STAFF REPORT:	C.U.P. 22-22 Round Valley Haven Subdivision - Preliminary Plat
HEARING DATE:	July 14, 2022
TO:	Planning and Zoning Commission
STAFF:	Cynda Herrick, AICP, CFM Planning and Zoning Director
APPLICANT/ PROPERTY OWNERS:	Philip Portsche and Ted Larson 12126 N 18th AVE Boise, ID 83714
SURVEYOR:	John Russell Surveying P.O. Box 945 McCall, ID 83638
LOCATION:	10373 Highway 55 RP12N04E190004 & RP12N04E190480 NENE Section 19, T.12N, R.4E, Boise Meridian, Valley County, Idaho
SIZE:	34 acres
REQUEST:	Single-Family Residential Subdivision
EXISTING LAND USE:	Single-Family Residential Parcel and Productive Timber Land

Philip Portsche is requesting a conditional use permit for a 2-lot single-family subdivision on 34 acres. This request is to correct an illegal property split that occurred in 2016.

Parcel #RP12N0E19-0480

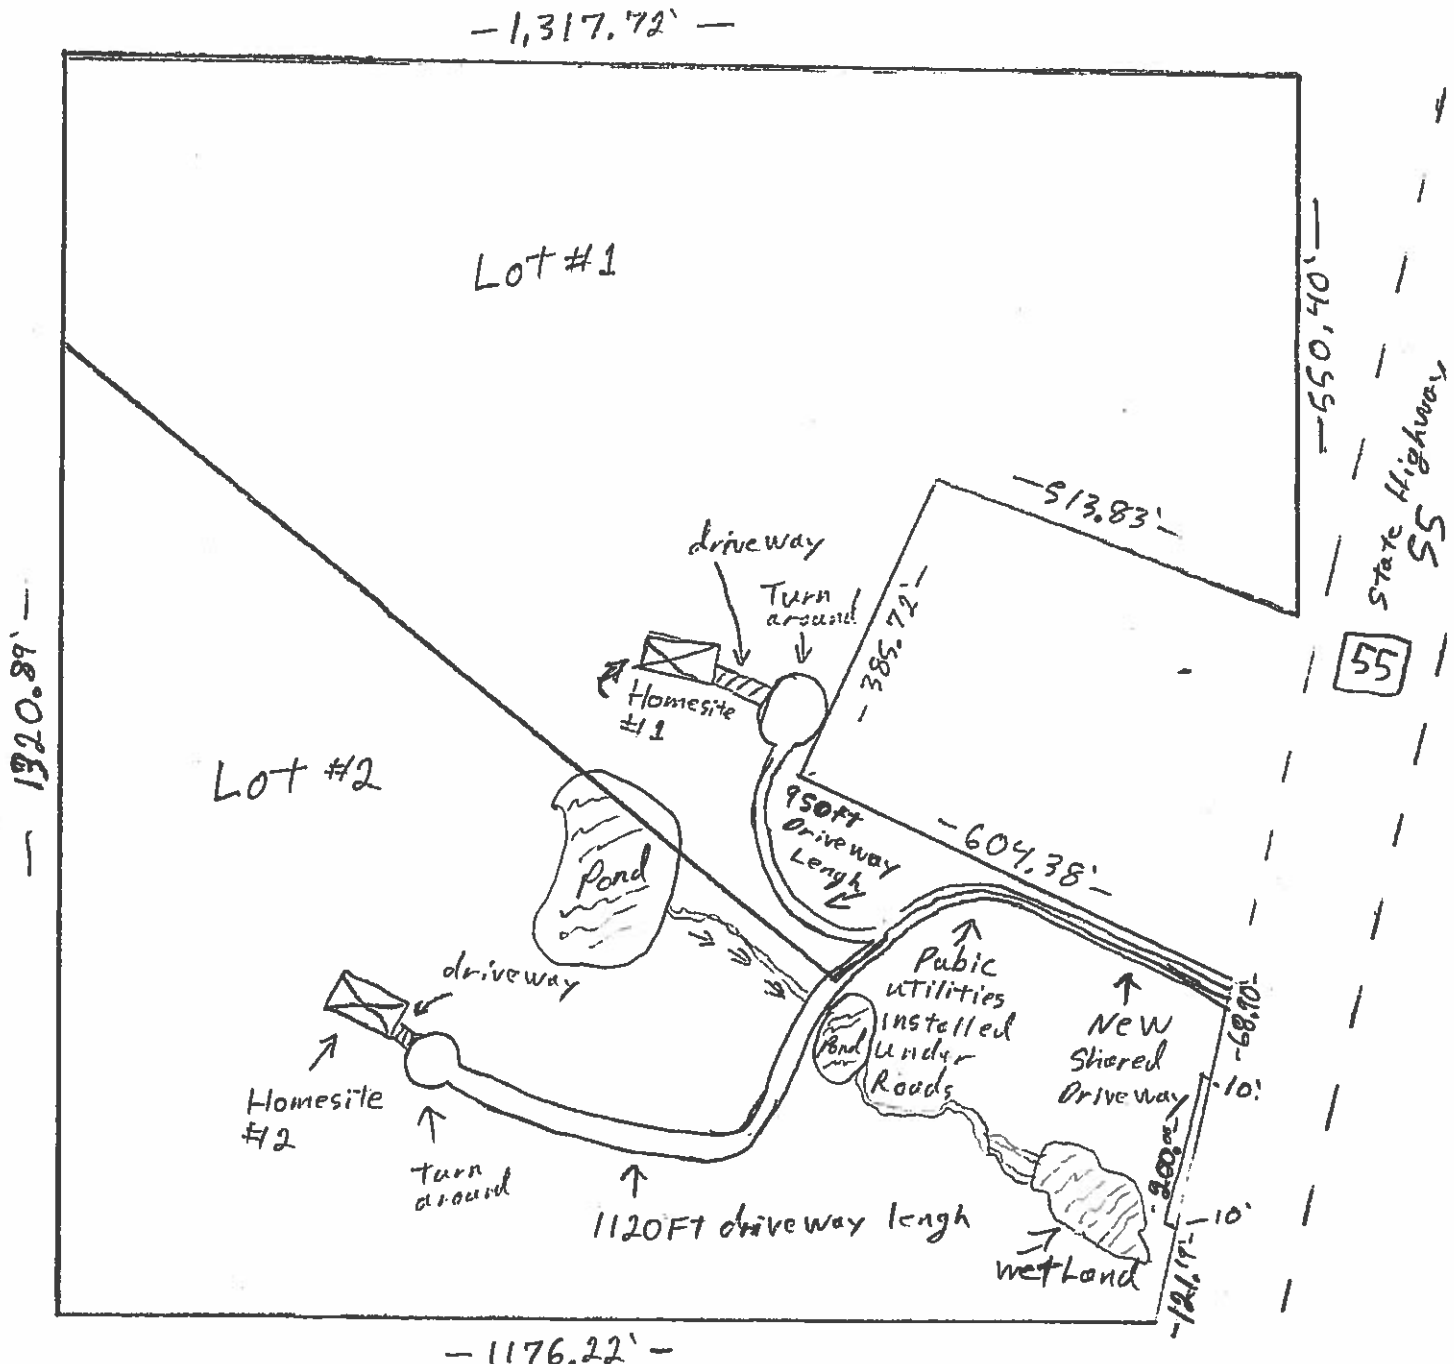
1. This site is within the Cascade Rural Fire District.
2. This site is not within an irrigation district nor a herd district.
3. Wetlands shall be designated on the final plat. There is a minimum 30-ft setback from high water line.
4. Frontage on a public or private road shall not be less than thirty feet (30') for each lot or parcel. The lot width at the front building setback line shall not be less than ninety feet (90').
5. A revised preliminary plat showing 30-ft frontage for Lot 1 is required.
6. A shared driveway maintenance agreement must be recorded.

5. A Declaration of Installation of Utilities shall be recorded and noted on the face of the plat.
6. A letter of approval is required from Cascade Rural Fire District prior to recording the final plat.

7. A shared-driveway maintenance agreement is required prior to recordation and must be noted on the face of the plat.
8. All easements shall be shown on the final plat, including the shared driveway.

9. Wetlands shall be marked as "no-build areas" on final plat.
10. CCR's should address lighting, wildfire prevention, noxious weeds, septic maintenance, hydrant maintenance, fire wise wildland urban interface landscaping requirements, floodplain and wetlands, and limit each lot to one wood burning device. CCR's should also address irrigation and surface water.
